MIL-R-83536/15
AMENDMENT 1
15 December 1995

MILITARY SPECIFICATION SHEET

RELAYS, ELECTROMAGNETIC, ESTABLISHED RELIABILITY, 4PDT, LOW LEVEL TO 10 AMPERES, PERMANENT MAGNET DRIVE HERMETICALLY SEALED, ALL WELDED, DC COIL

This amendment forms a part of MIL-R-83536/15, dated 27 March 1992, and is approved for use by all Departments and Agencies of the Department of Defense

SOCKET PIN TERMINAL .

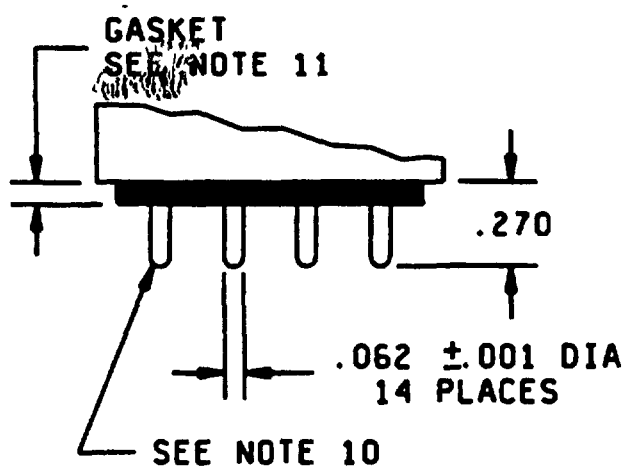
FIGURE 1, socket pin terminal diagram, delete and substitute
